Response to request for information memo

Tilbuster Solar Farm

February 2022

Project Number: 20-729

Appendix G Zone of visual influence map

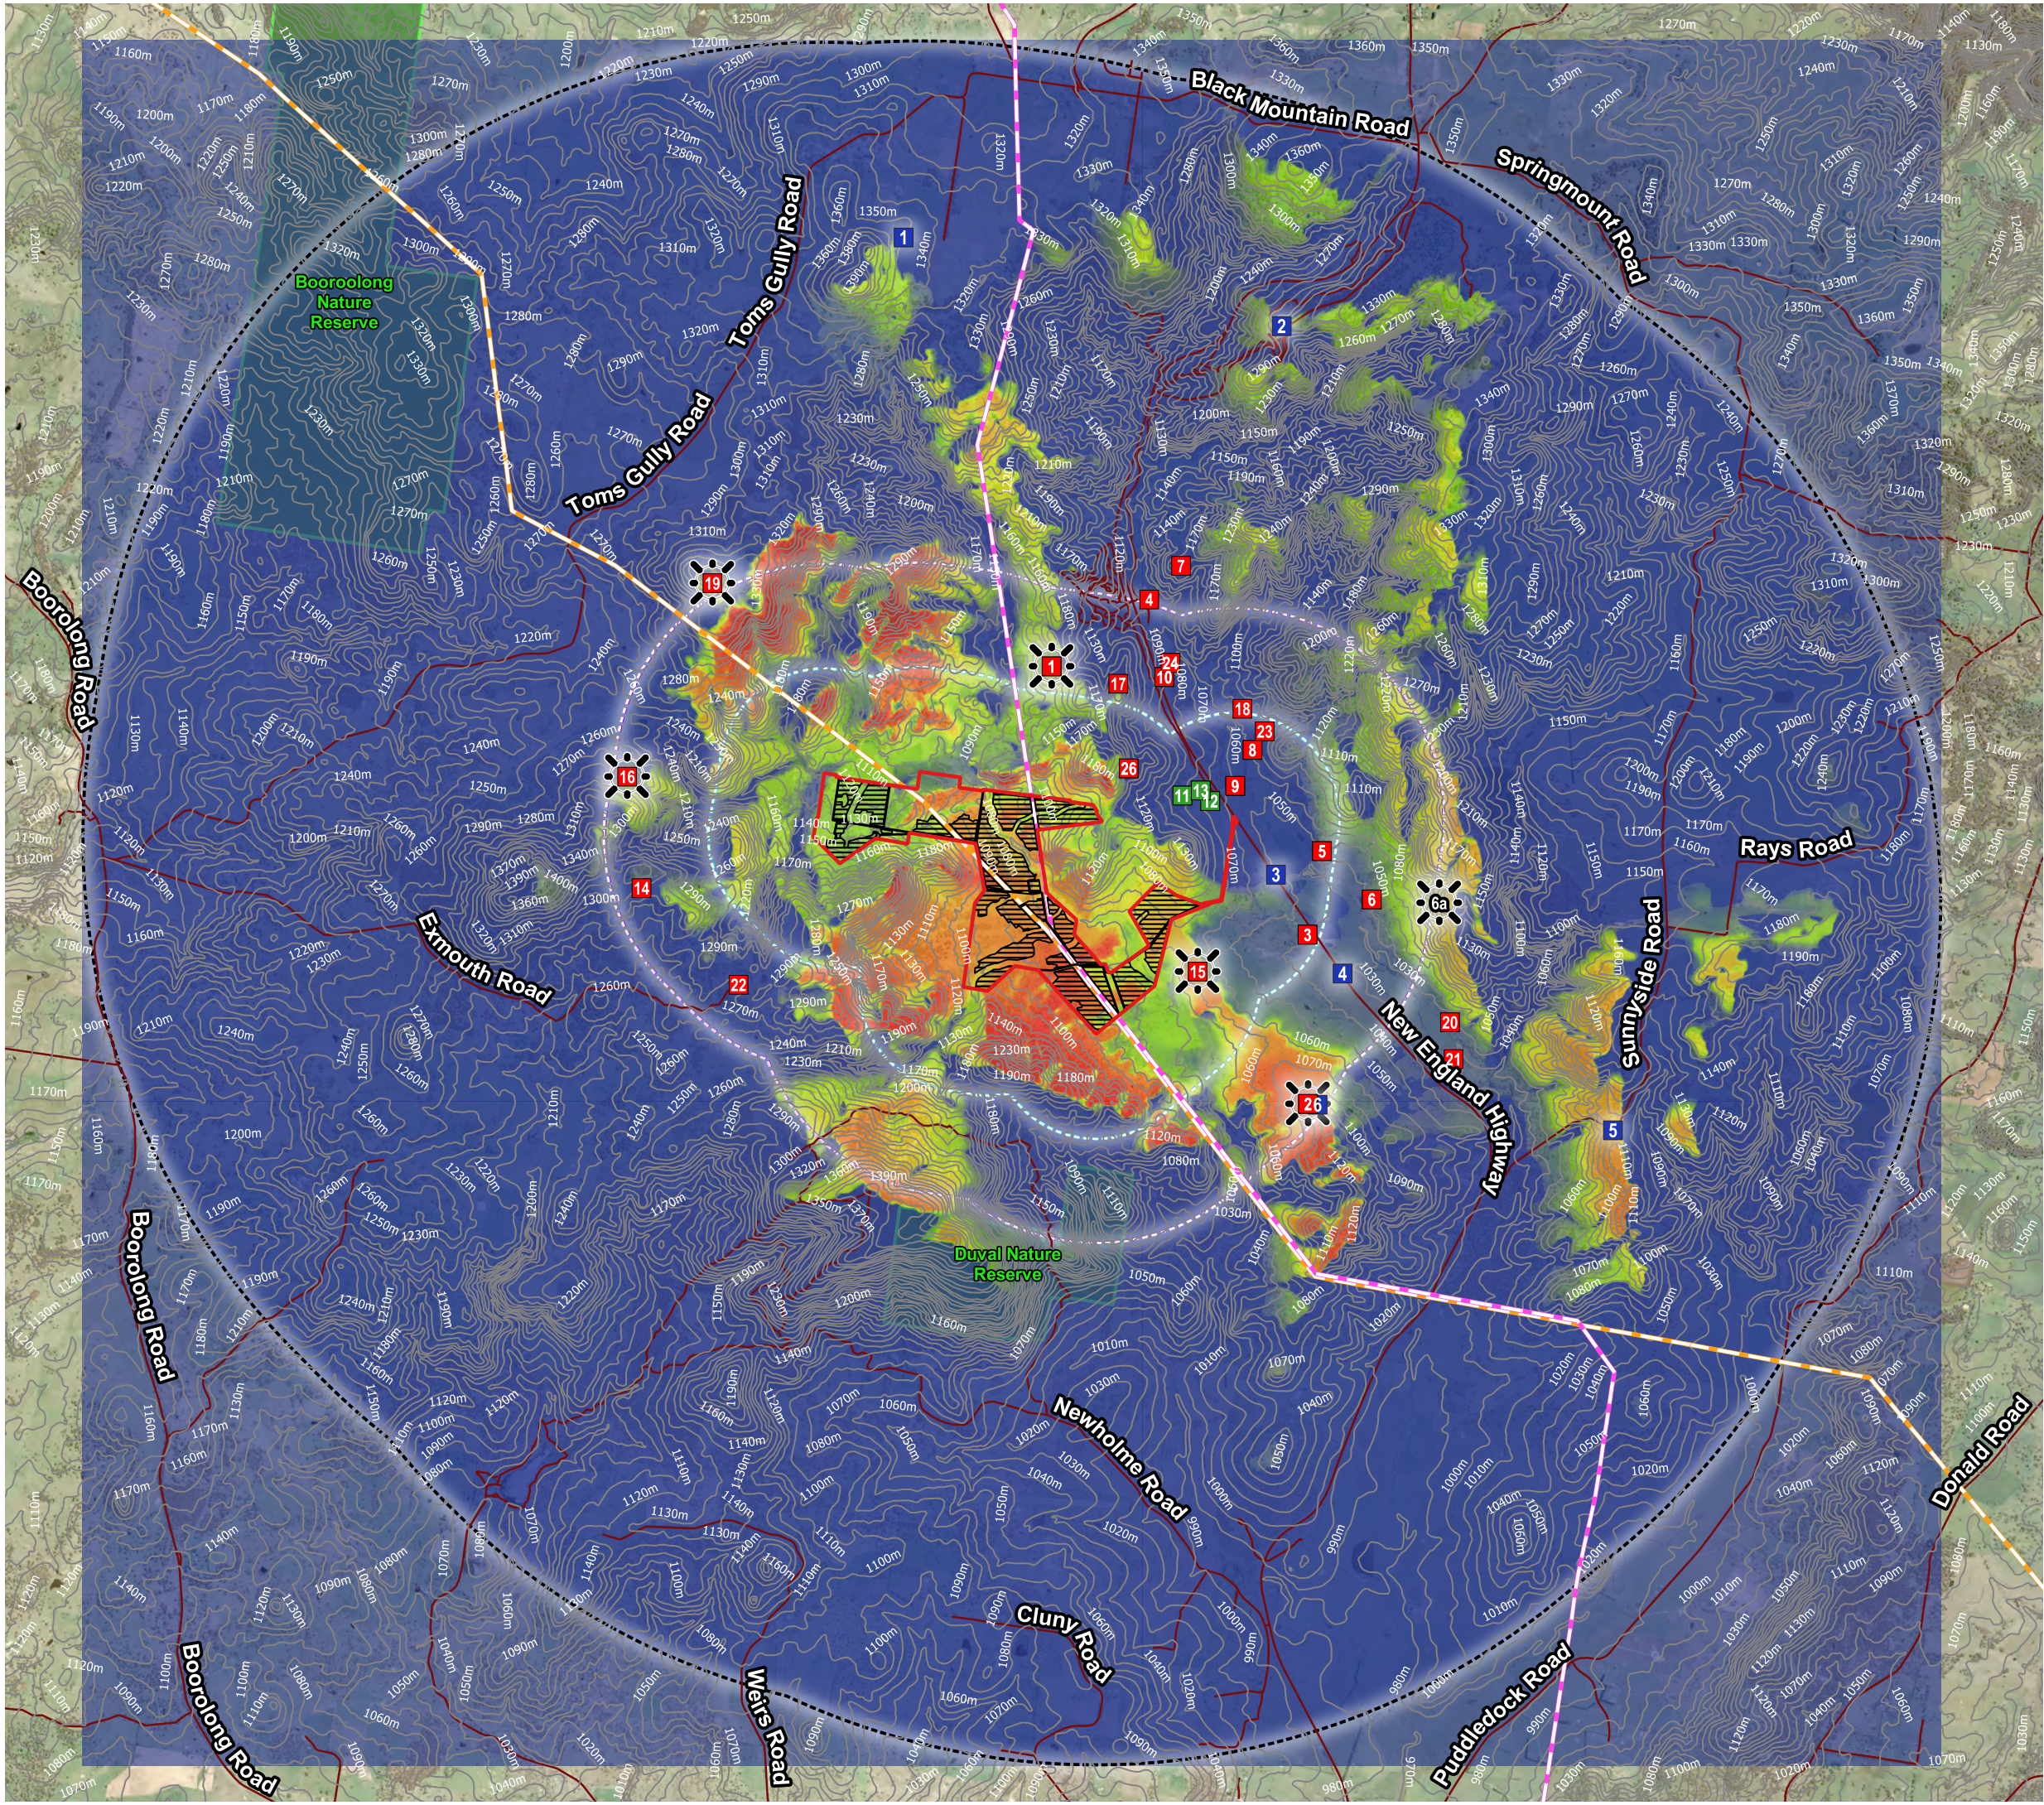
- Provide an amended figure (Figure 4-3 in the Amendment Report), reflecting the current development footprint.
- Provide an amended figure (Figure 8-1 in the EIS), including all receivers and viewpoints.

An updated figure is presented in Appendix G which includes the visual receptors assessed for glint and glare impacts.
